**STAFF REPORT: JULY 8, 2020 MEETING**

**APPLICATION NUMBER: 20-6770**

**ADDRESS: 1225 WOODWARD AKA *THE FOWLER BUILDING***

**SCOPE OF WORK: REHAB BUILDING, REPLACE WINDOWS, STOREFRONT SYSTEM**

SIGHT LINE STUDY: LOOKING FROM THE SOUTHWEST CORNER OF WOODWARD AVE AND GRATIOT AVE - ROOFTOP EQUIPMENT NOT VISIBLE

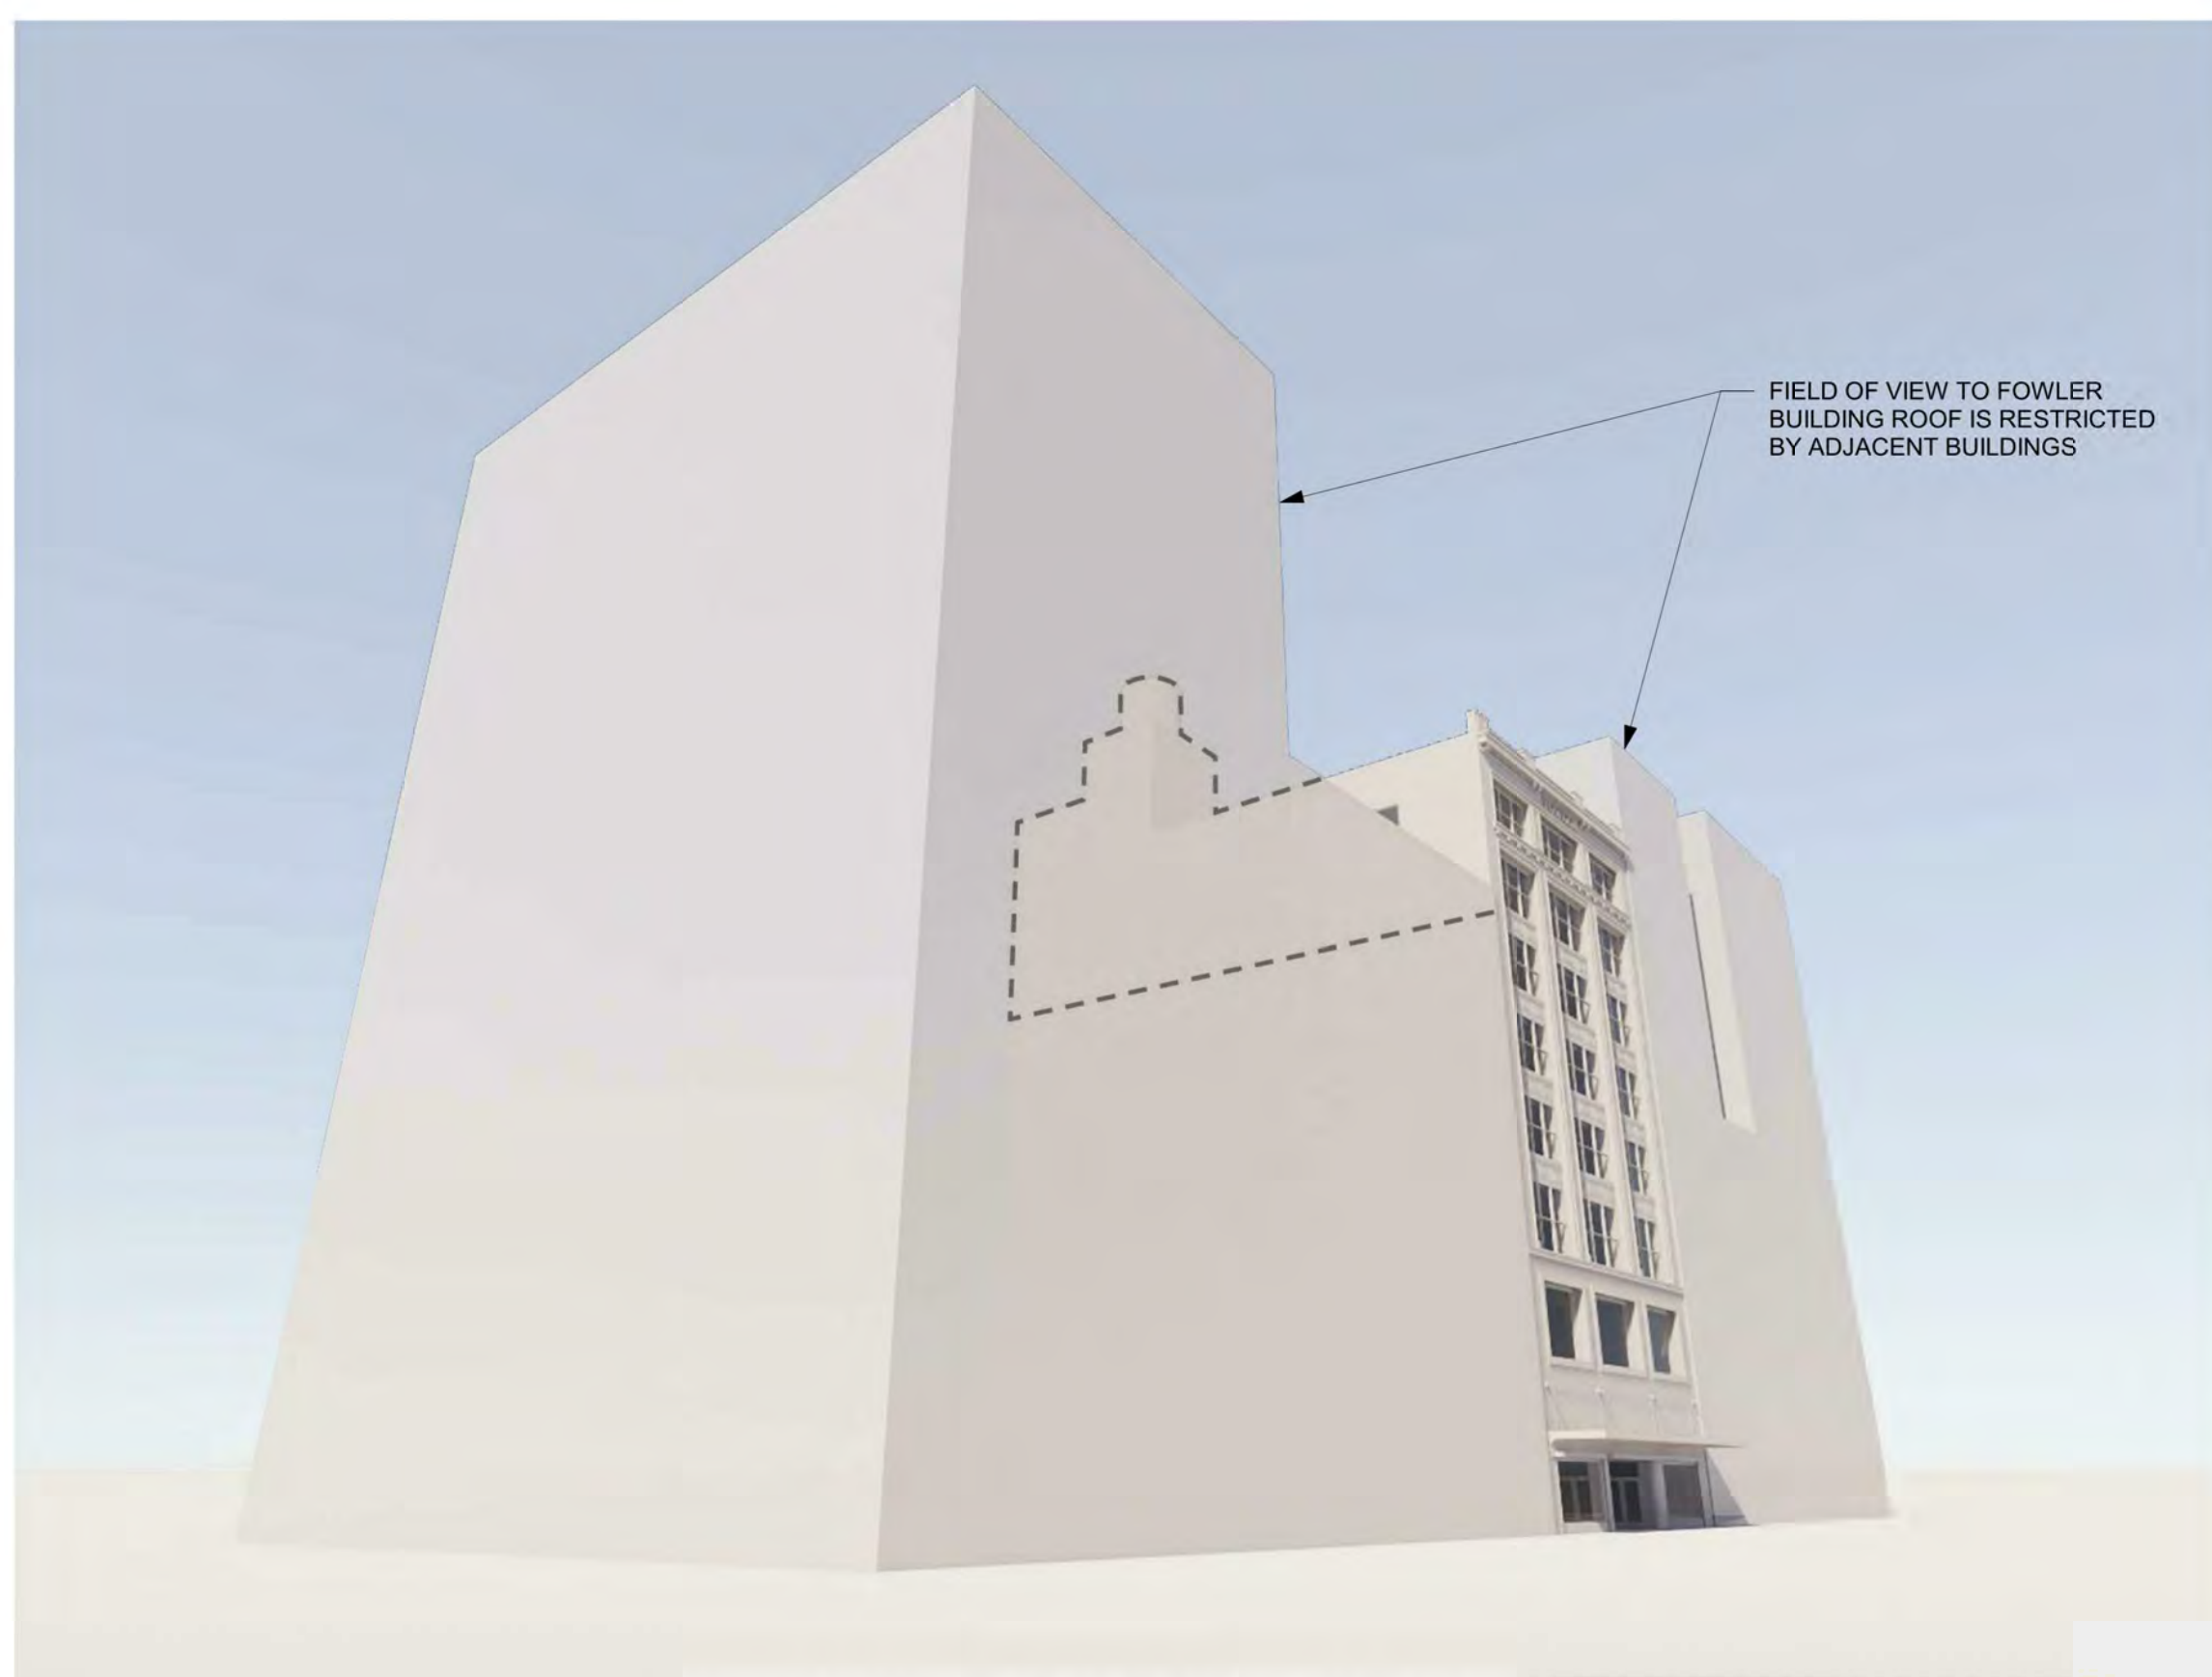
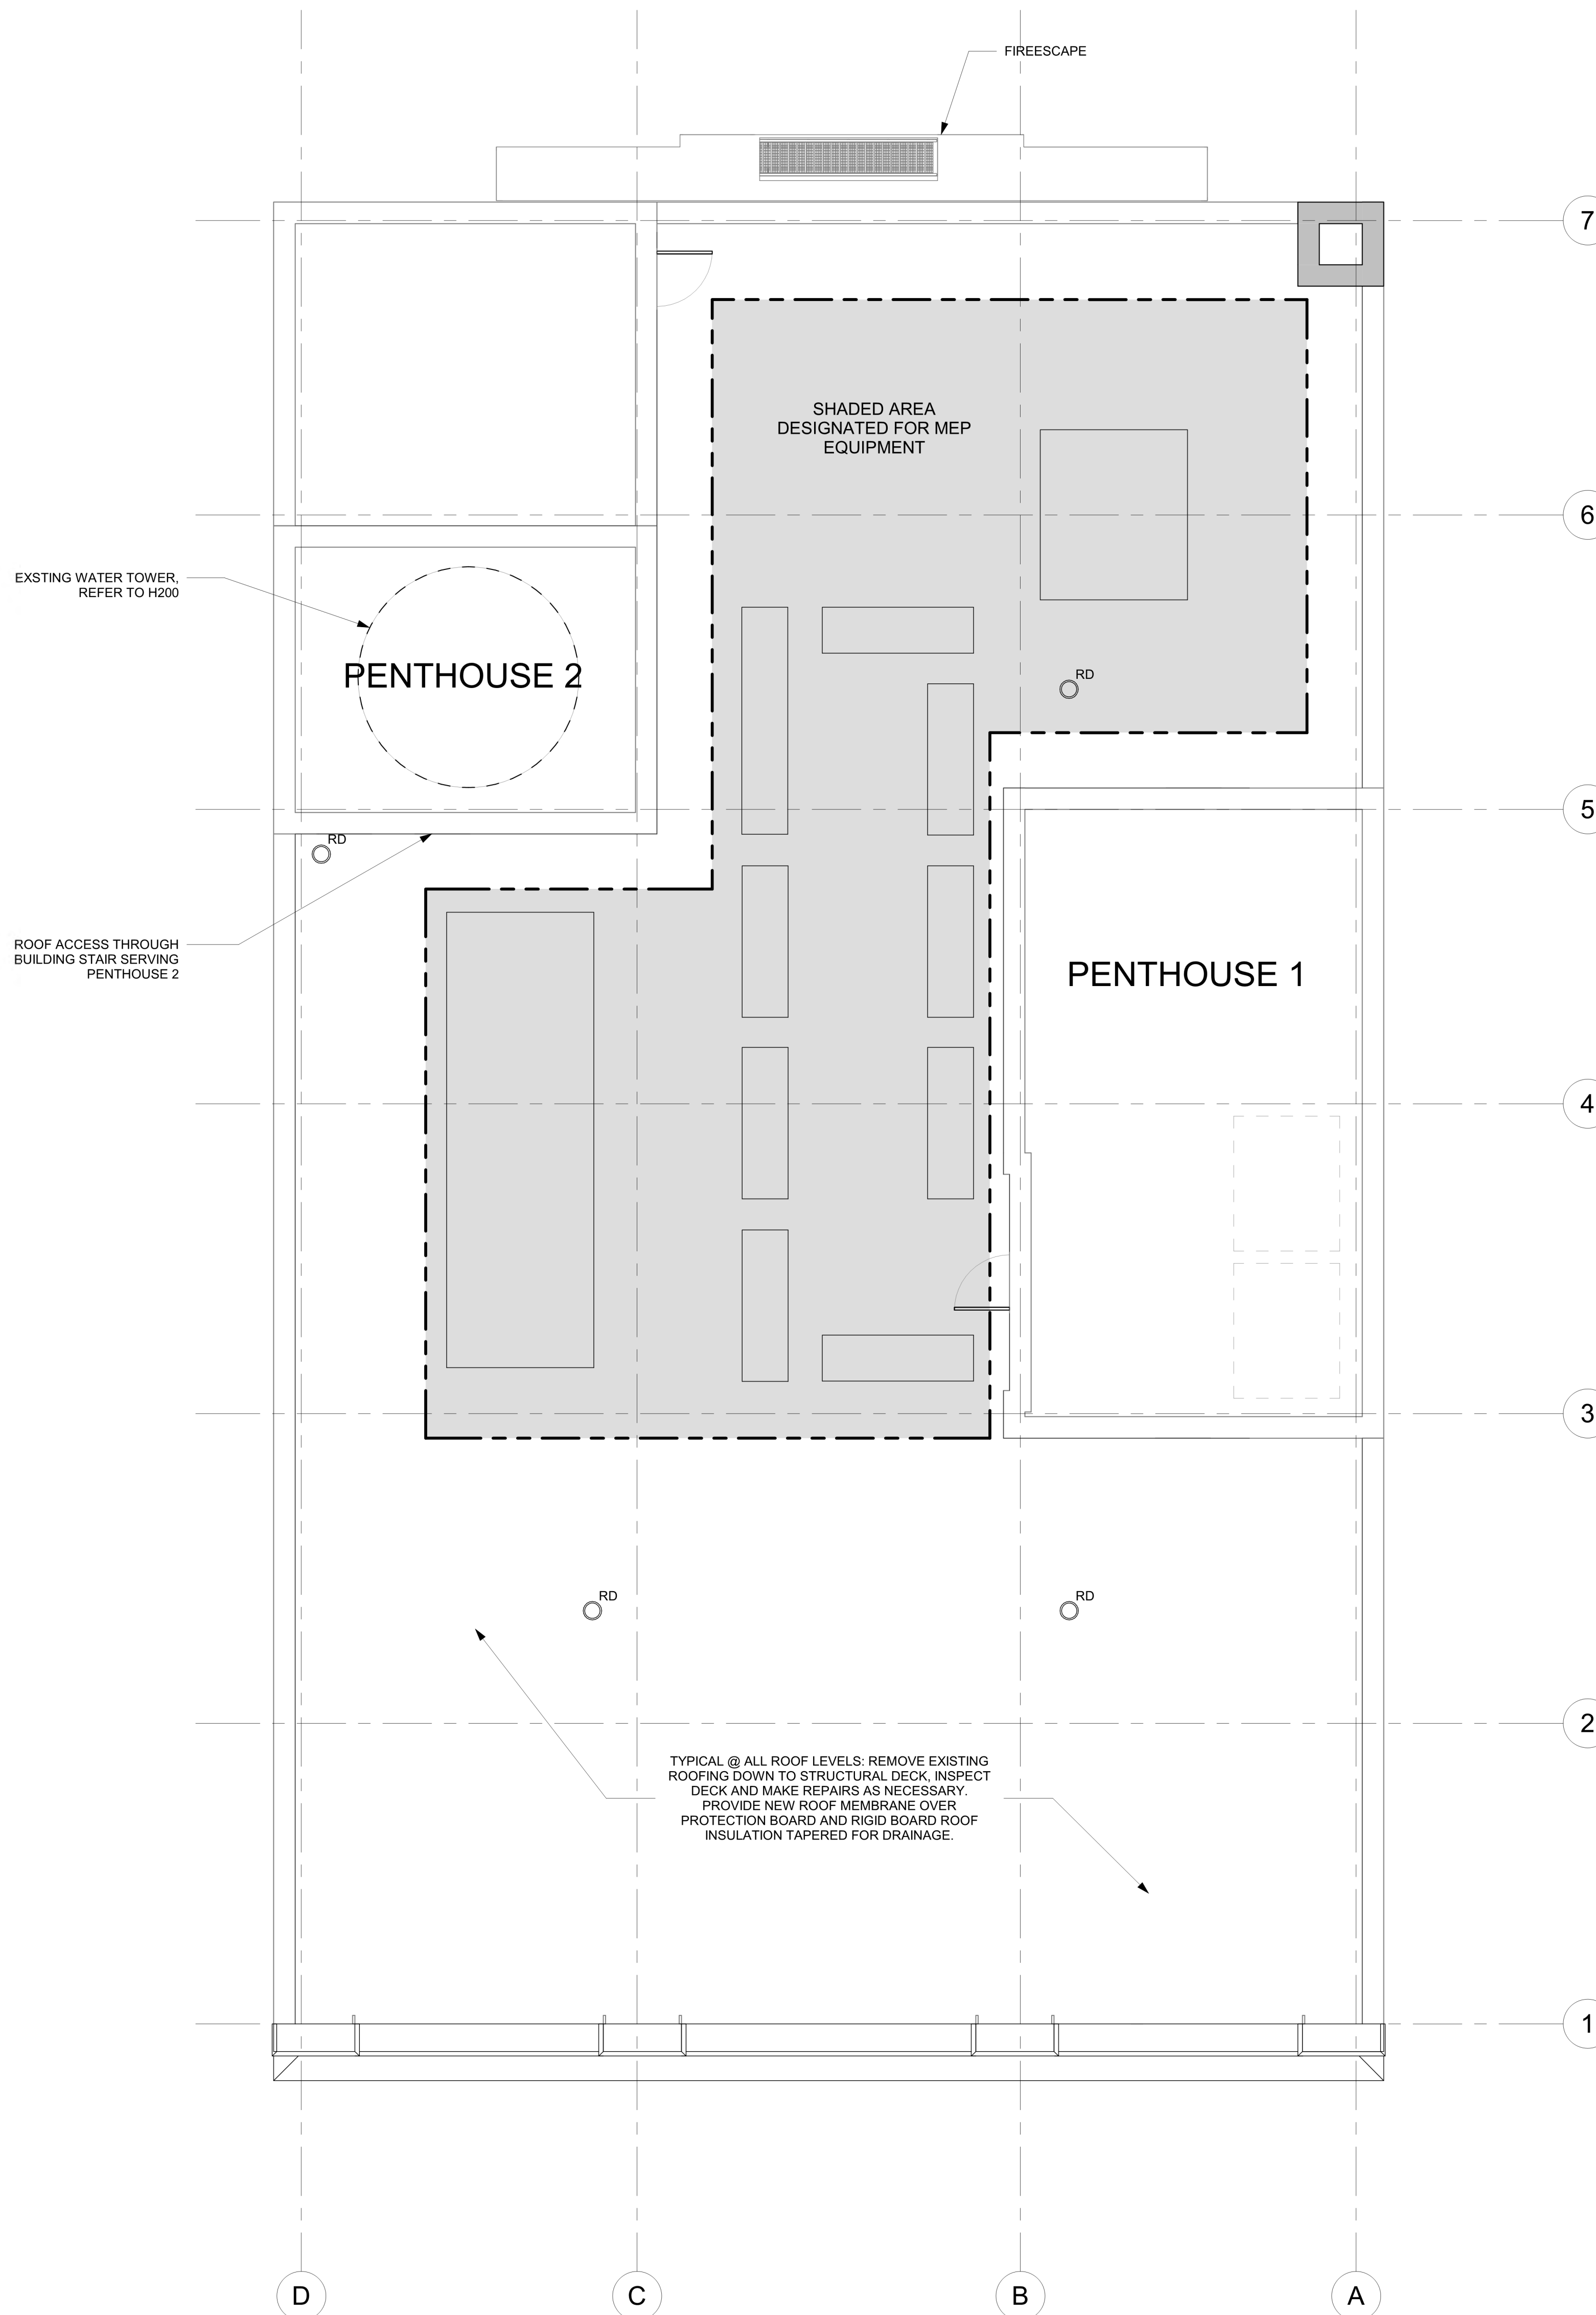
- Remove existing black rubber roof membrane and replace with new EPDM roofing material in black
- Add new HVAC and mechanical units behind existing penthouses at NW corner of roof

1. A sightline study was provided
2. Final rooftop equipment cutsheets and layouts were not available at this time

1. The applicant shall provide a final lighting plan.
2. The applicant shall provide a final rooftop plan and specs for all new equipment installed on the roof.
3. All future signage (independent of location) be reviewed by HDC staff as a separate application.
4. Applicant submit specs for fire escape, replacement doors.
5. Applicant submit samples of proposed brass paneling and replacement granite.
6. Applicant will expand on masonry cleaning techniques and will submit test patches of masonry and terra cotta.

EXISTING  
"WILLIAMS PIVOT SASH"  
TO BE REMOVED.

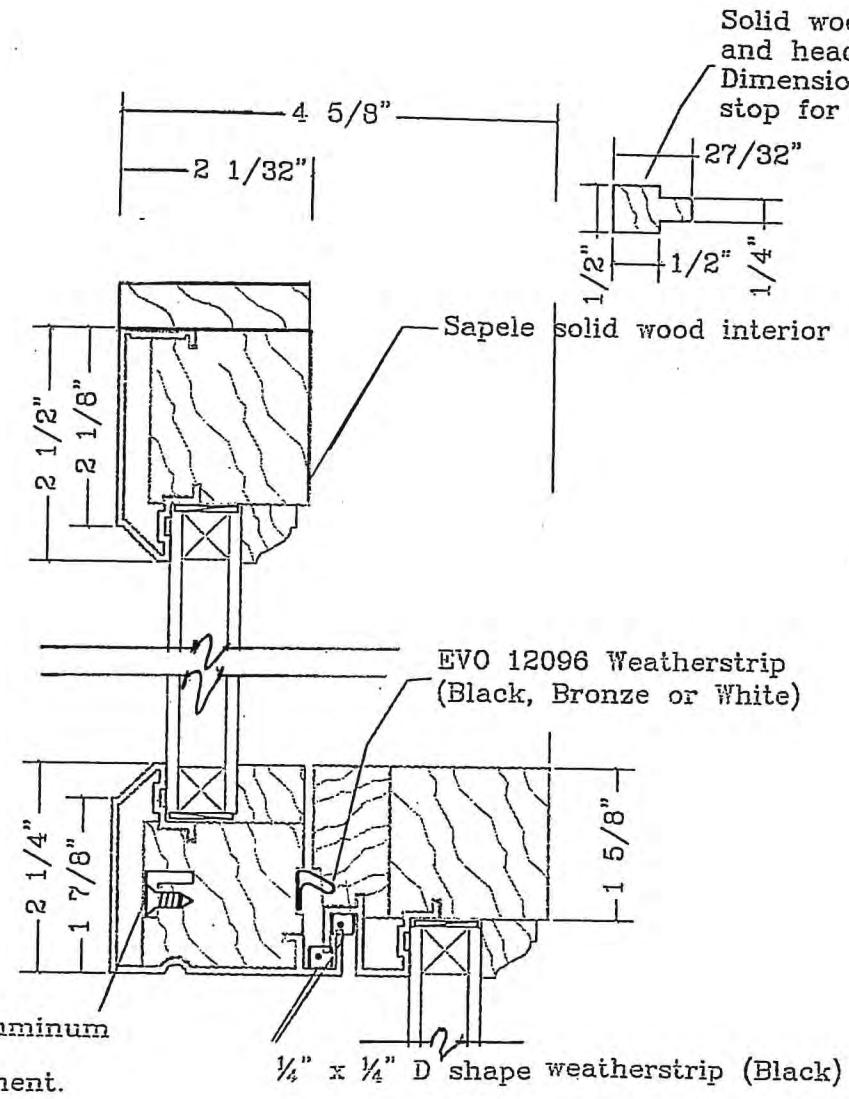
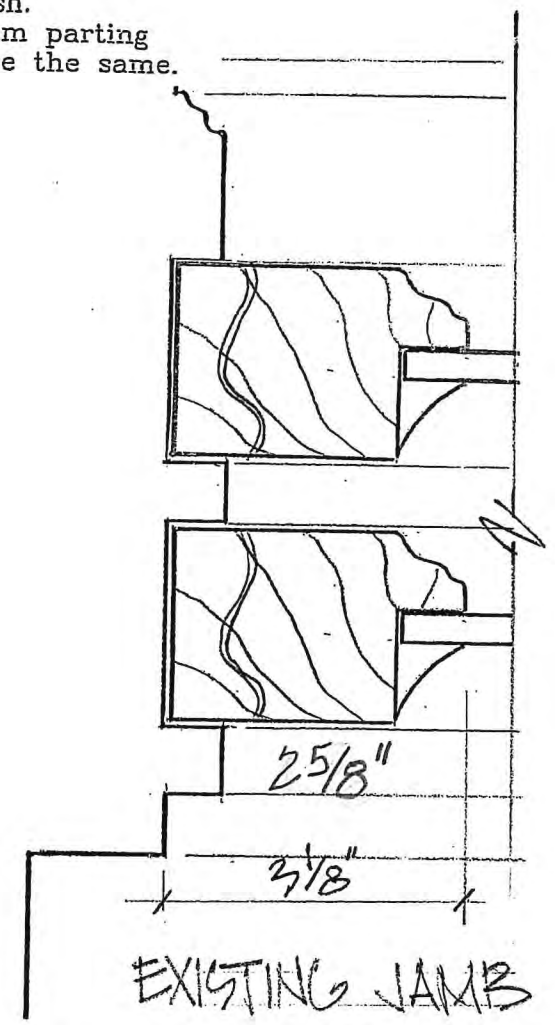
- **It is staff's opinion that the proposed replacement window sashes, while not matching the existing operation, are a very close replacement to the existing measurements.** The installation of which, will not result in the loss of any character defining details.

Finally, on the east façade, on floors three through eight, there are three sets of three windows per floor. Each window is a proprietary pivot sash double hung window from the era that is no longer in production. (see attached report for more detail on the window type) The window frames and associated trim are bronze-clad and painted green. The window units are composed of one-over-one double hung wood sashes. The window sashes are not metal clad like the surrounding frames and trim.

Because of the unique character of these proprietary windows, replacement hardware for these window components is generally not available. Moreover, given the deterioration of the sash components and structural limitations and deflection of the original sashes, it is not recommended that these sashes be restored (especially with the additional weight of new IGUs), and instead this project proposes to restore the frames and replace the wood sashes with new metal clad wood sashes that match the size and profiles of the original wood sashes. The new window sashes shall be fixed in place. See attached replacement window details.

PROPOSED  
ALUMINUM CLAD FIXED SASH  
IN EXIST'G COPPER CLAD FRAMES
